MONTGOMERY COUNTY HISTORIC PRESERVATION COMMISSION
STAFF REPORT

Address:	12 E. Lenox St., Chevy Chase	Meeting Date:	10/28/2020
Resource:	Contributing Resource Chevy Chase Village Historic District	Report Date:	10/14/2020
Applicant:	Justin and Elizabeth Bausch	Public Notice:	10/7/2020
Review:	HAWP	Staff:	Dan Bruechert
Case Number:	35/13-20FF	Tax Credit:	n/a
PROPOSAL:	Accessory building, arbor installation, and hardscape alterations

Garden House

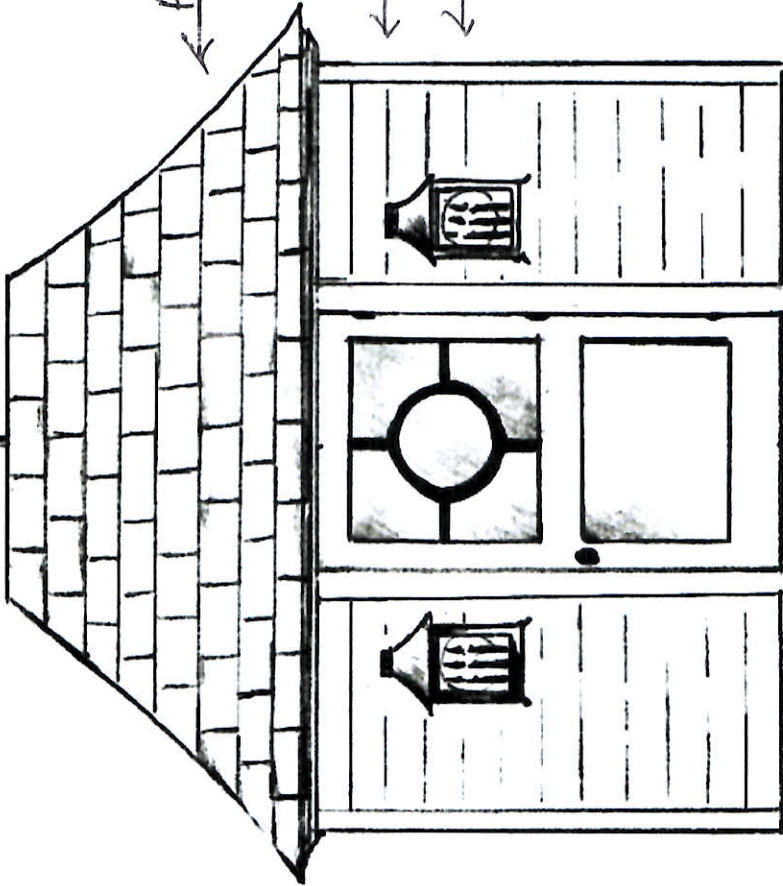
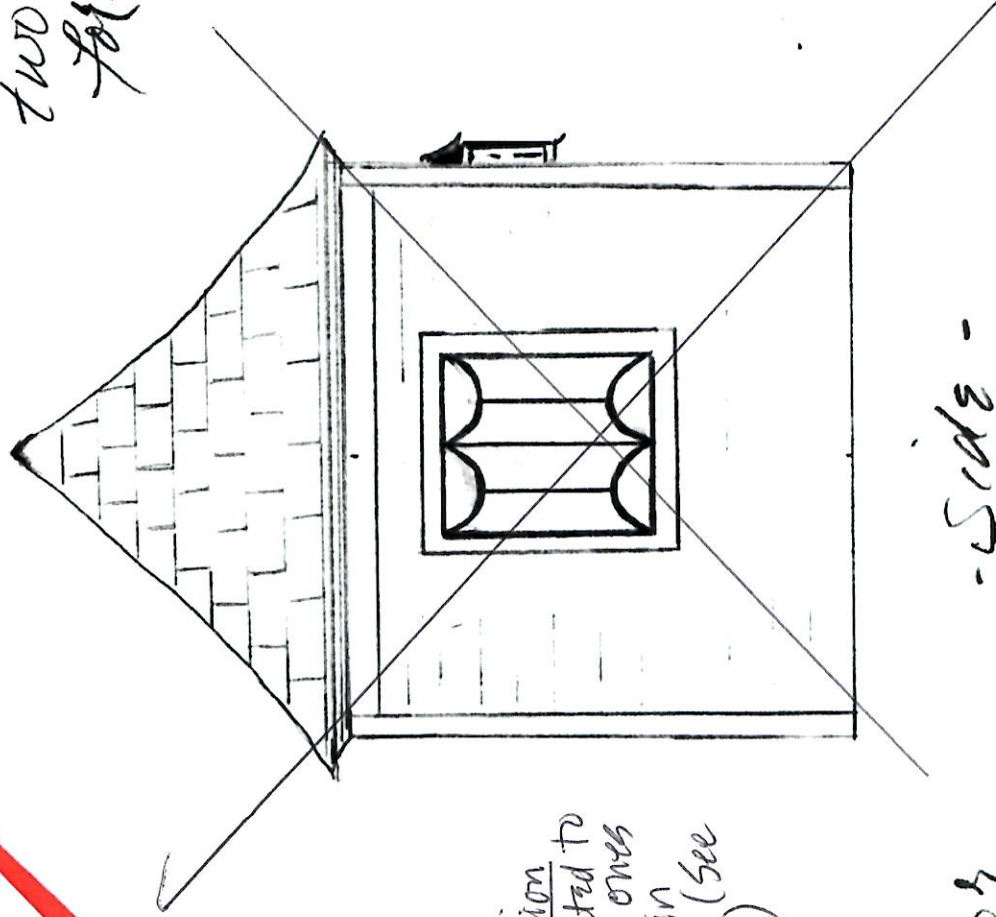
The applicant proposes to construct an accessory structure, measuring 12' × 8' (twelve feet by eight feet), in the southwest corner of the lot. The structure will be sided in wood and have a pyramidal roof with architectural shingles. The front door of the structure will be custom made to match the house front door. Because of the open side yard, the accessory structure will be visible from the public right-of-way (see below). As a garden structure, the *Design Guidelines* state the proposal should be reviewed under 'Moderate Scrutiny.' No trees will be impacted by the proposal.

Staff finds that the architectural character of the accessory structure is compatible with the historic house and the surrounding district. Additionally, Staff finds that the size of the structure will not overwhelm the historic house. Staff recommends the HPC approve the proposed accessory structure.

Arched Arbor with a Westchester Double Gate

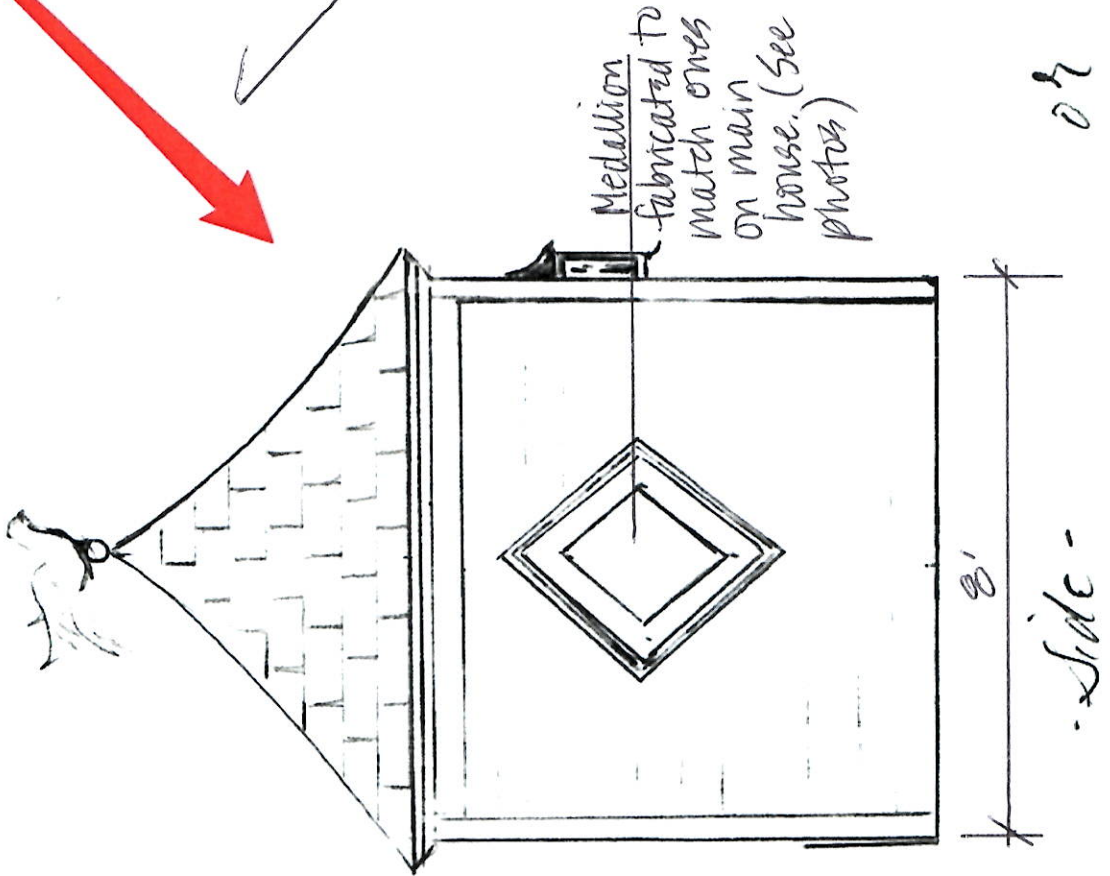
As part of the new landscape plan, the applicant proposes to install a new arbor to the west (right) of the house. The arbor will be wood, 6' (six feet) wide and approximately 10' (ten feet) tall. The proposal will have the arbor free-standing, flanked by shrubbery on either side.

Staff finds that the design, materials, and dimensions of the proposed arbor will not detract from the historic house or surrounding district. Staff additionally finds that the arbor will be easily removed from the site without destroying the historic fabric, per Standard 9. Staff Recommends the HPC approve the proposed arbor.

TITLE: PLANTING PLAN, Rev

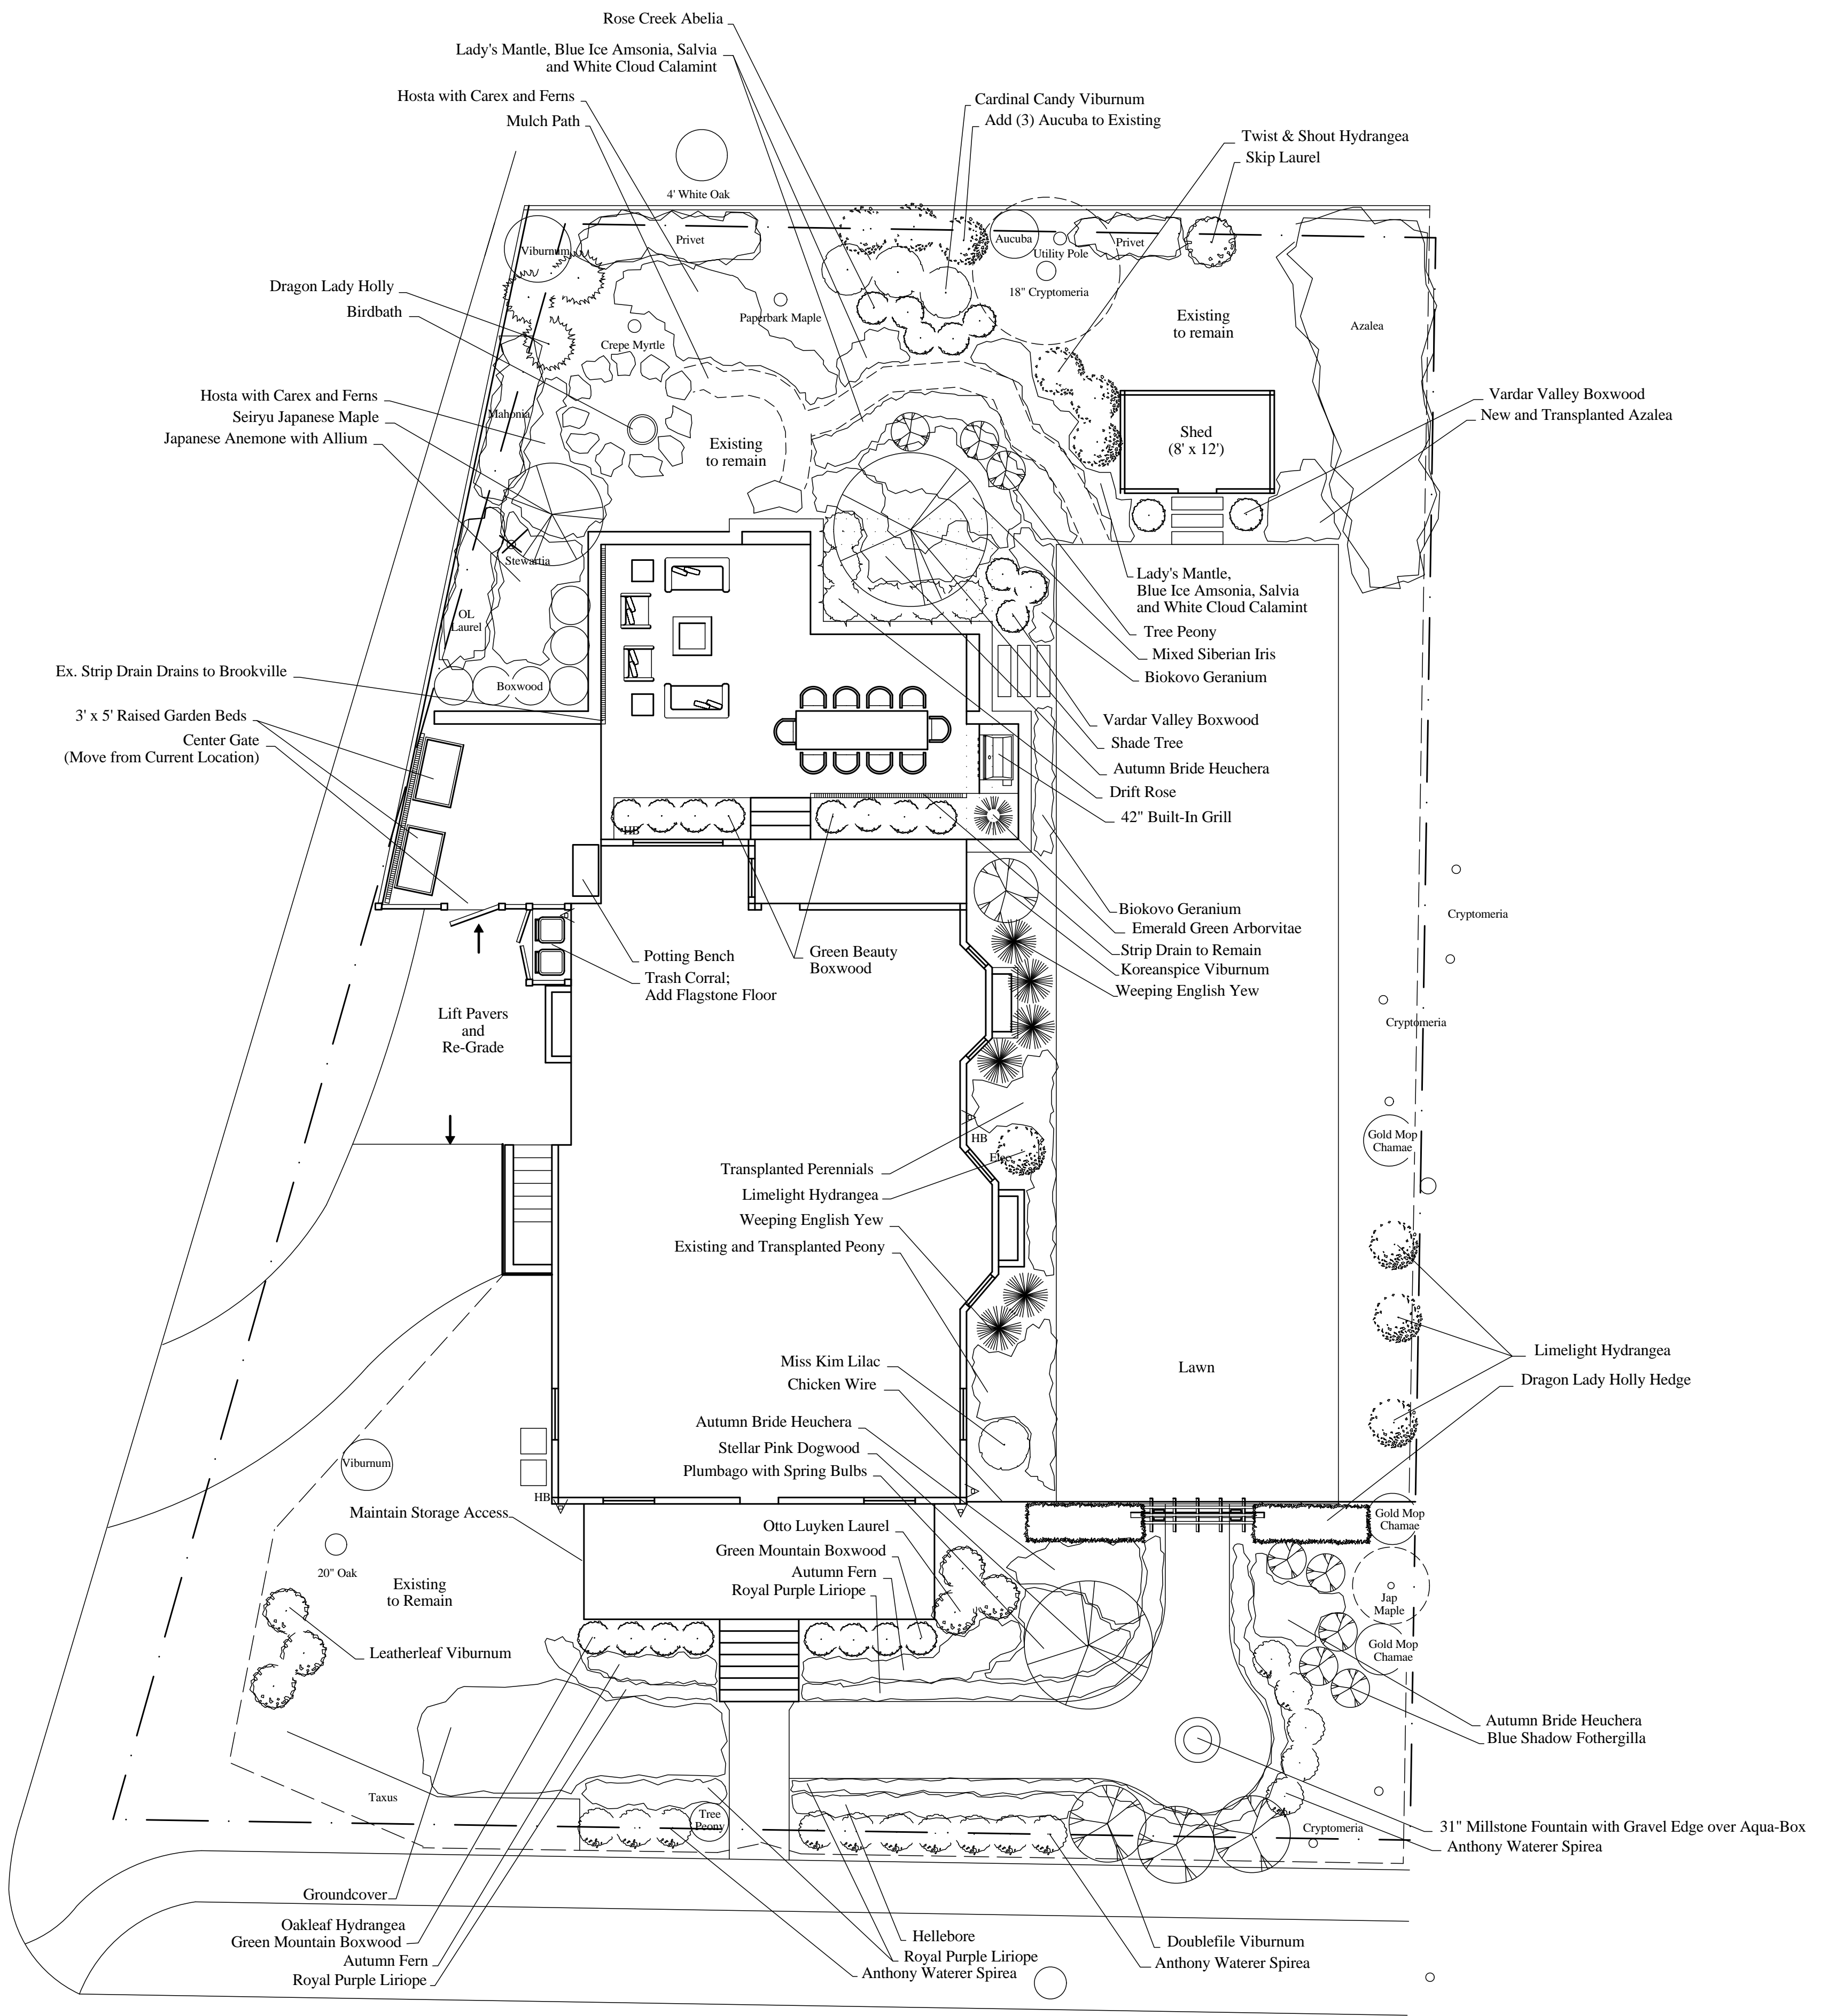
The applicant proposes extensive alterations to the hardscaping on the property. Most of the hardscape work is to the rear of the house. In the northwest corner, the applicant proposes to install a millstone fountain. To the rear of the house, the applicant proposes to install a new patio wall matching the existing walls, installing a new flagstone patio surface, installing new pavers between the patio and the proposed accessory structure, and installing a plant bed.

Staff finds that the proposed millstone fountain will have a minor impact on the character of the site and surrounding district. Additionally, because it will be on grade, it will not be visible unless you are immediately adjacent to it. The other work proposed for the rear will be obscured by the house and will not be visible from the right of way. The *Design Guidelines* state that alterations not visible from the public should be given a very lenient review. Staff finds that the proposed hardscaping will not alter the character of the house or the surrounding district and recommends the HPC approve the work.
